TO:	**City Council**
VIA:	Ritchie Haynes, City Manager
DATE:	September 3, 2026
FROM:	Scott Clark, Assistant City Manager
PREPARED BY:	Scott Clark, Assistant City Manager
SUBJECT:	Public Services Facility Change Order for Entrance/Parking Lot

City Council is requested to approve a change order for the Public Services Facility Project

Re: Parking Lot Remedial Recommendations
Lincolnton Public Services Center
500 Sigmon Rd.
Lincolnton, North Carolina
CVET Project No.: 26-083

FIGURE 1

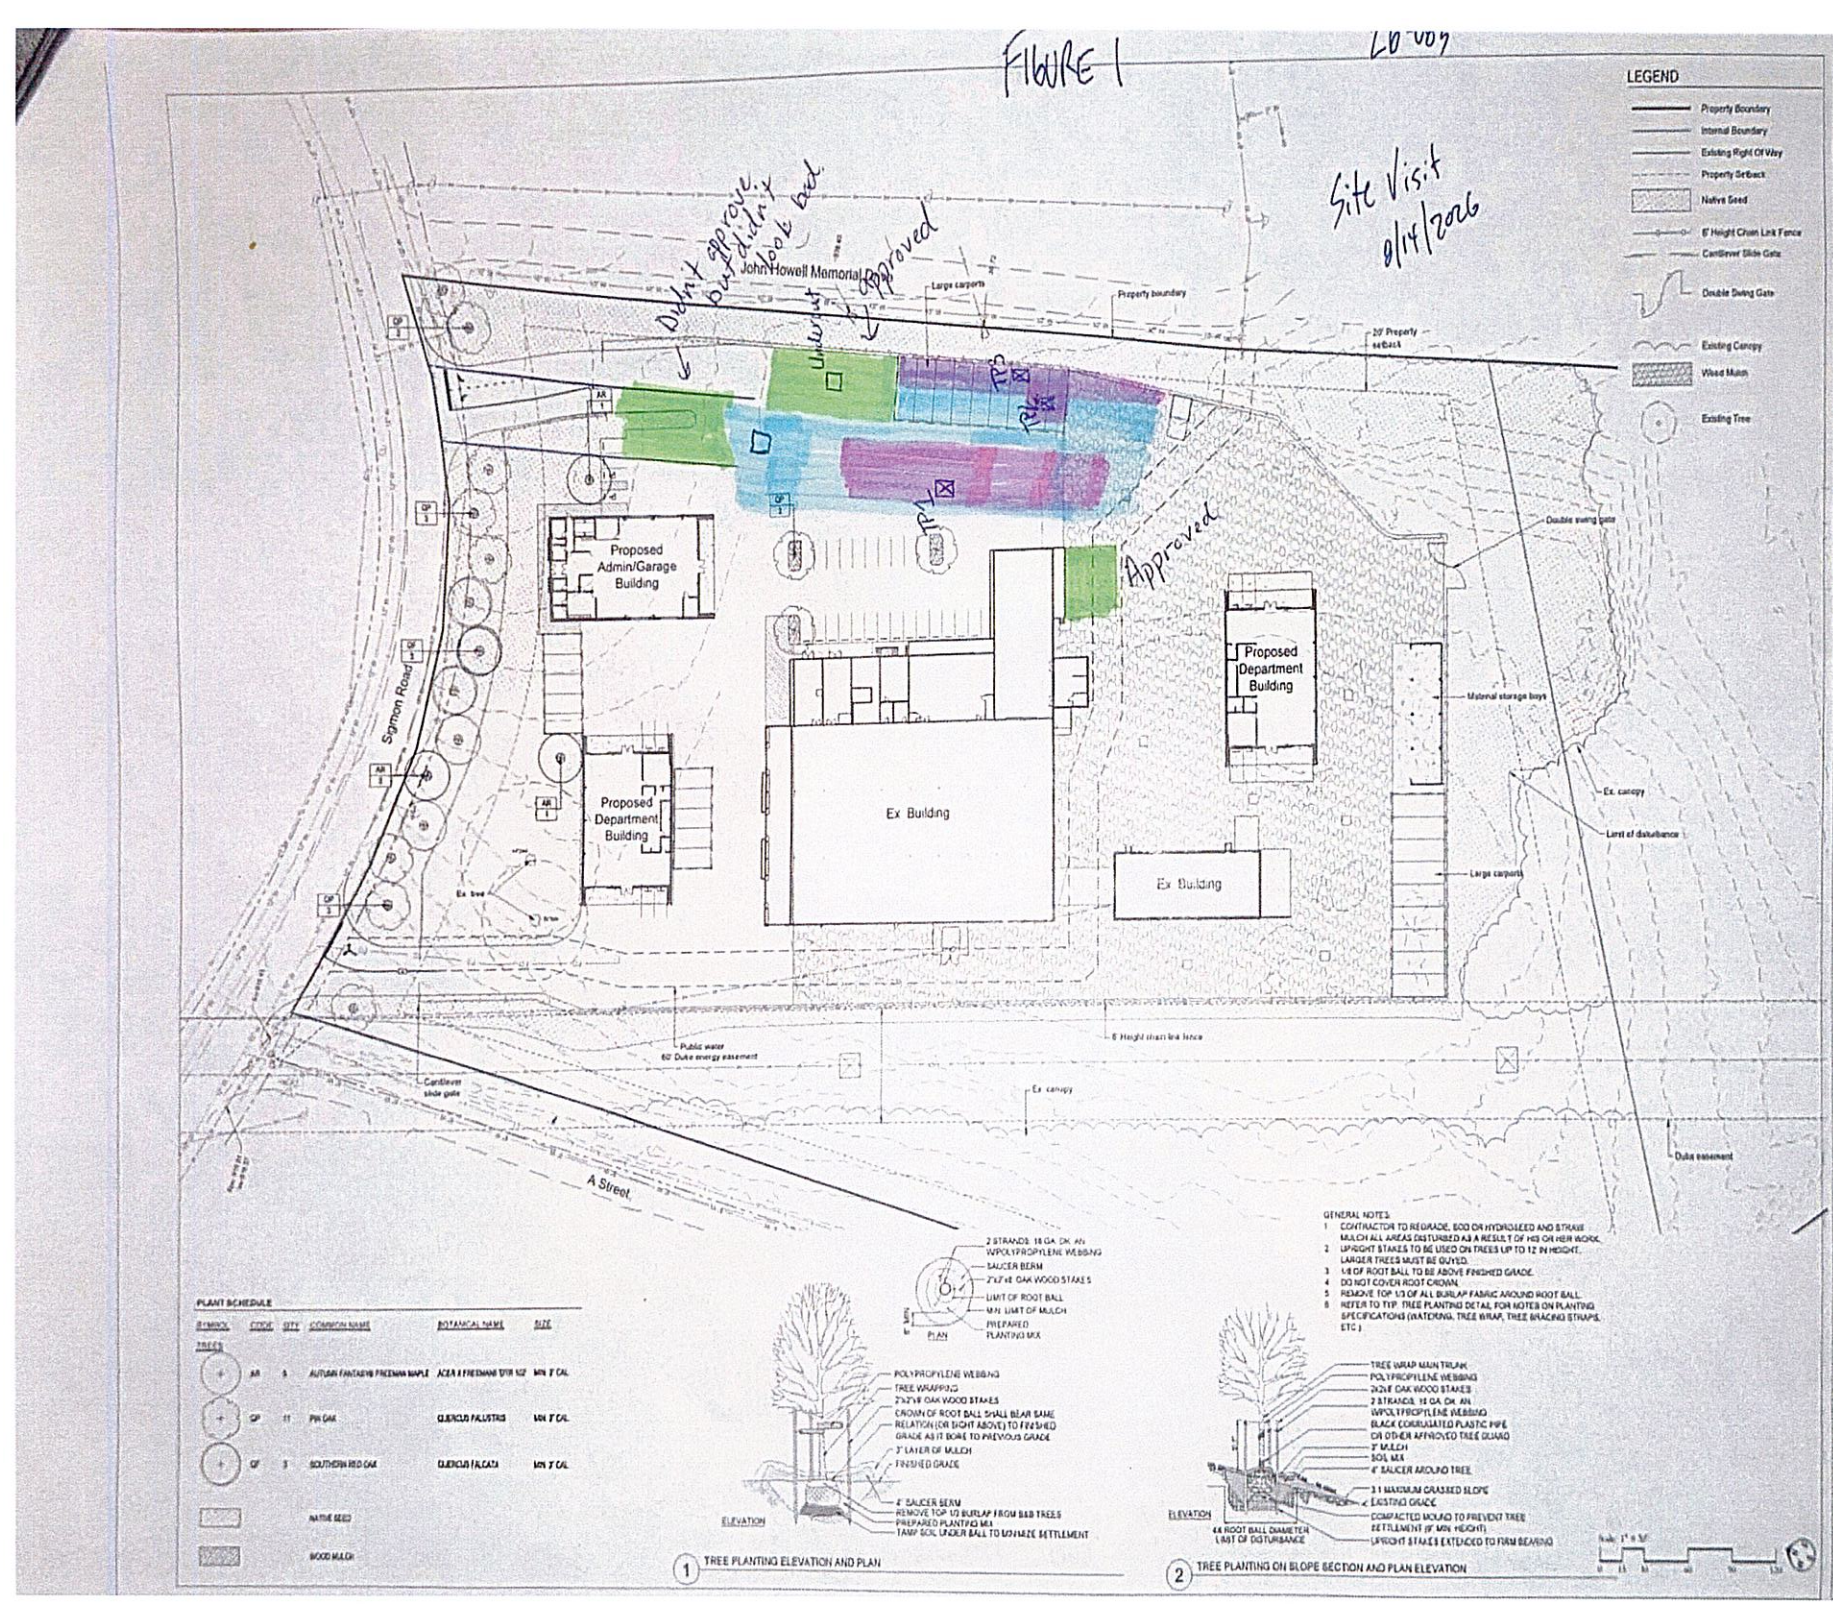
CVET observed a proofroll on August 14, 2026, on the exposed subgrade soil within the approximate area displayed on the appended sketch. The areas denoted in green on the appended sketch were stable under the load of the proofroll and were approved after surficial subgrade remediation. The areas denoted in blue and pink on the appended sketch were unstable under the load of the proofroll. Unstable areas were further evaluated by excavation of three (3) shallow test pits (TP) at the approximate locations on the appended sketch. TP-1 was terminated at a depth of 4 feet below existing subgrade elevation and did not penetrate the low consistency, dark gray, wet sandy clay. TP-2 and TP-3 were terminated at depths ranging from approximately 2 to 3 feet below existing subgrade elevation, where suitable bearing soils were encountered.

Based upon the observations during the proofroll, areas of remediation have been recommended before construction of the overlying pavement system. Three options for remediation have been generated, along with their respective level of associated risk and are as follows:

1 Lowest Risk – Highest Cost

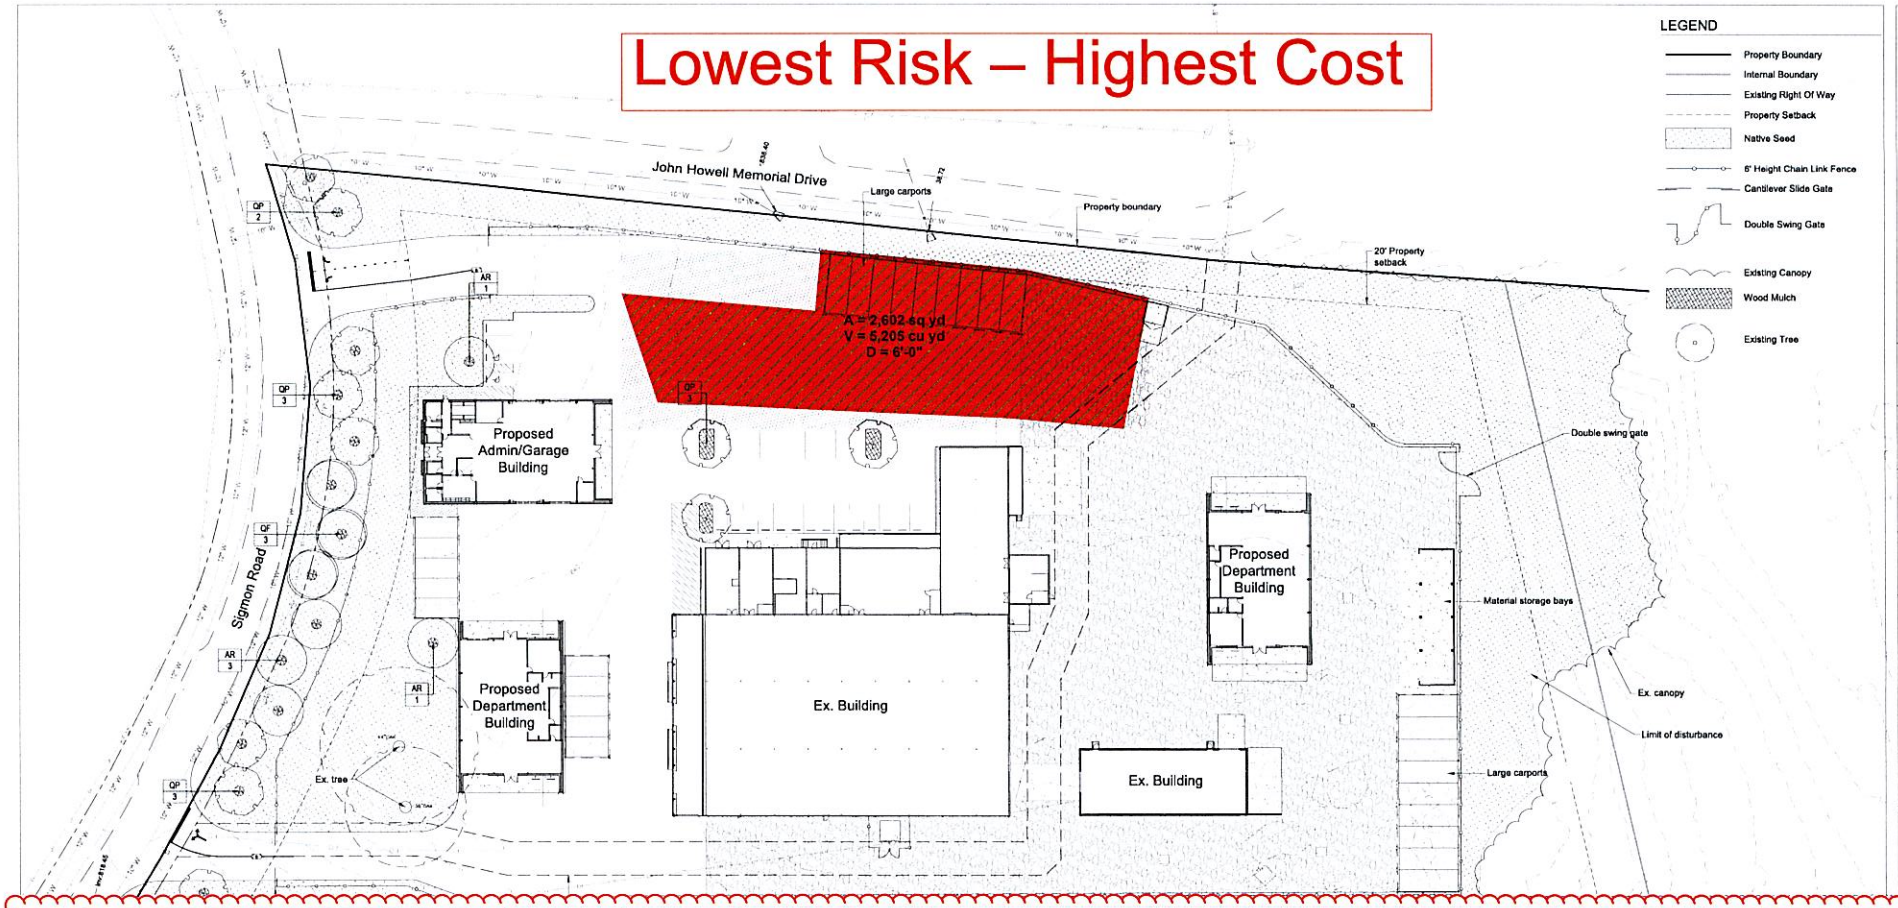
The lowest risk option to address the unstable soils encountered in the parking lot areas would be to completely remove and replace the low consistency soils. If this option is elected, the undercut should extend to suitable bearing soils and no greater than 6 feet below soil subgrade elevation. The base of the undercut should be evaluated by CVET prior to backfilling with approved structural fill soil. The structural fill soil is recommended to be compacted to the specifications presented in the Geotechnical Engineering Report dated October 25, 2024, and prepared by CVET (Project No.: 24-573). This option will not be the most economical option, but the risks associated with the existing low consistency soils will be almost eliminated.

6' Undercut/Haul Off/Import Stone	Rate	Qty.	
Undercut Excavation, Haul Off (Per CY)	$ 30.00	5205	$ 156,150.00
Import ABC Stone (Per Ton)	$ 55.00	9108.75	$ 500,981.25
Fabric, HP G37 (Equivalent to HP 370)	$ 6.00	2600	$ 15,600.00
		Total:	**$ 672,731.25**

2 Moderate Risk

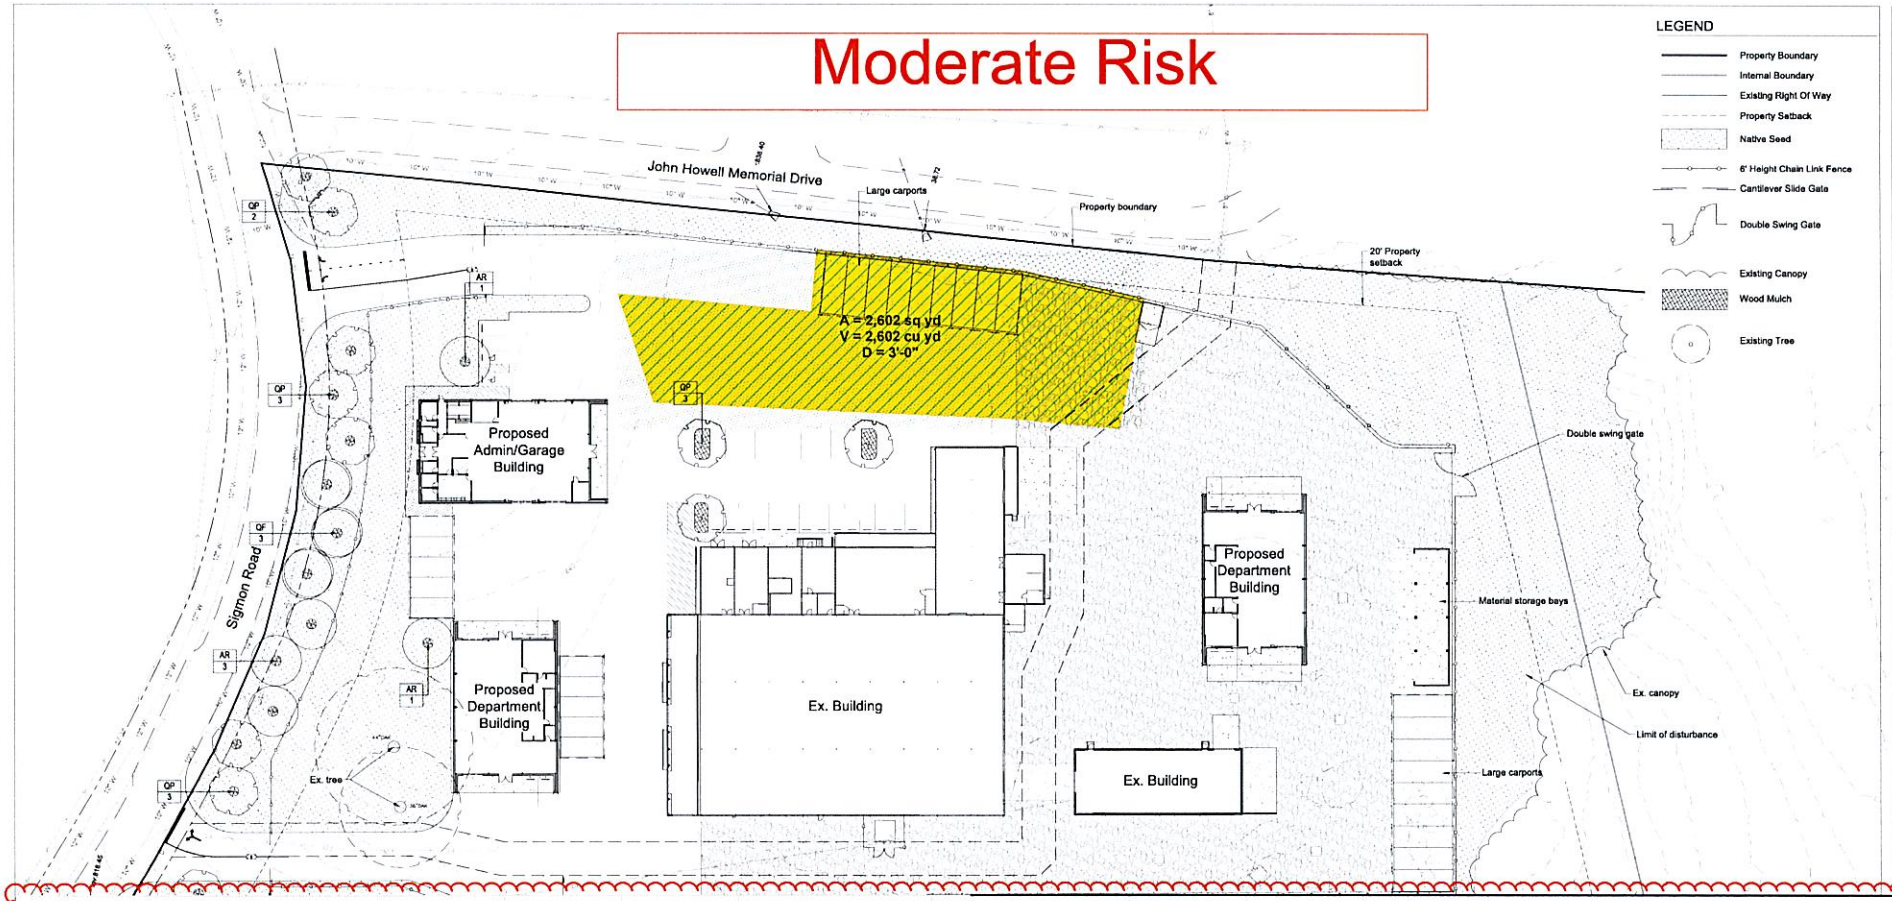
The moderate risk option to address the unstable soils encountered in the parking lot areas would be to perform a limited undercut and replacement of the low consistency soils. If this option is elected, the undercut should extend to a depth of 3 feet below soil subgrade elevation. Installation of a heavy, non-woven geotextile (Mirafi HP570 or approved equivalent) is recommended at the base of the undercut, prior to backfilling with compacted ABC stone to 100% of the standard Proctor method (ASTM D-698). This option will not completely eliminate the risks associated with the existing low consistency soils; however, the anticipated lifespan before maintenance is required is estimated to be in excess of 10 years.

3' Undercut/Haul Off/Import Stone	Rate	Qty.	
Undercut Excavation, Haul Off (Per CY)	$ 30.00	2602	$ 78,060.00
Import ABC Stone (Per Ton)	$ 55.00	4553.5	$ 250,442.50
Fabric, HP G37 (Equivalent to HP 370)	$ 6.00	2600	$ 15,600.00
		Total:	**$ 344,102.50**

3 Highest Risk – Lowest Cost

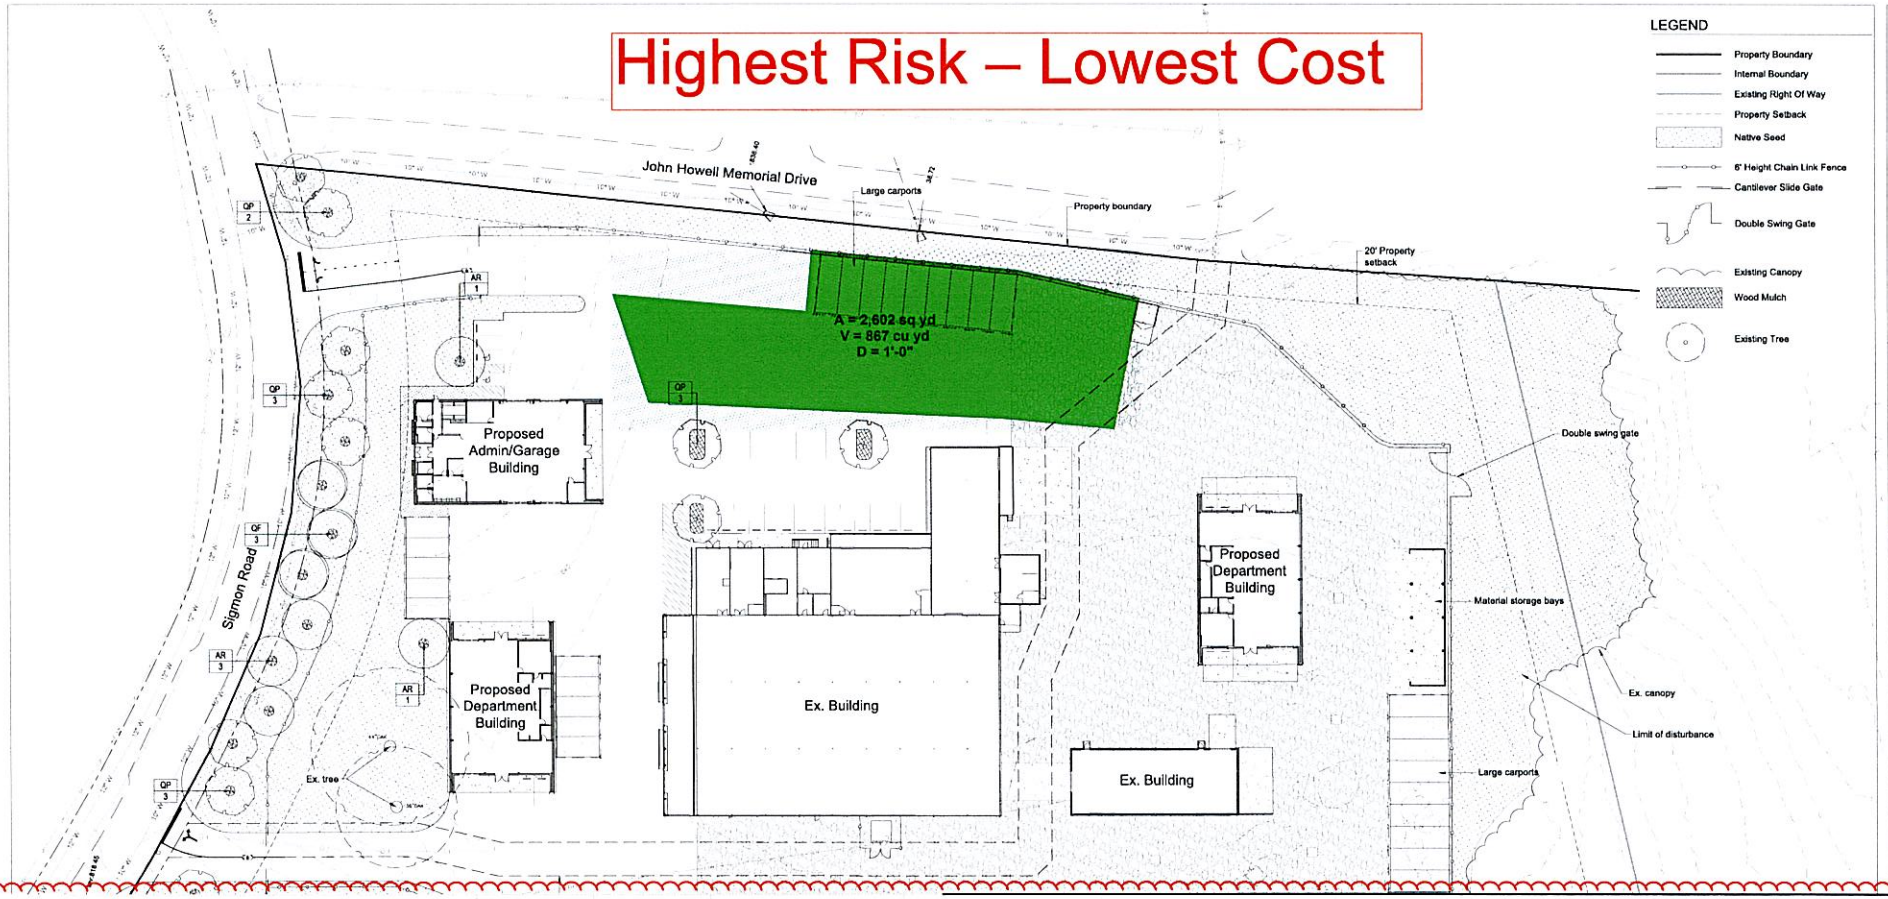
The high risk option to address the unstable soils encountered in the parking lot areas would be to perform minimal undercut and replacement with additional ABC stone base beneath the proposed pavement section. If this option is elected, the undercut should extend a minimum of 12-inches below existing subgrade elevation. Installation of a lighter, non-woven geotextile (Mirafi HP370 or approved equivalent) is recommended at the base of the undercut, prior to backfilling the undercut in a single lift of ABC stone. This option will not eliminate the risks associated with the low consistency soils. Routine maintenance of this area of parking should be anticipated within 5 years after construction. We recommend that if this option is elected, a maintenance budget be established to extend the lifespan of the pavement system.

1' Undercut/Haul Off/Import Stone	Rate	Qty.	
Undercut Excavation, Haul Off (Per CY)	$ 30.00	900	$ 27,000.00
Import ABC Stone (Per Ton)	$ 55.00	1575	$ 86,625.00
Fabric, HP G37 (Equivalent to HP 370)	$ 6.00	2600	$ 15,600.00
		Total:	**$ 129,225.00**
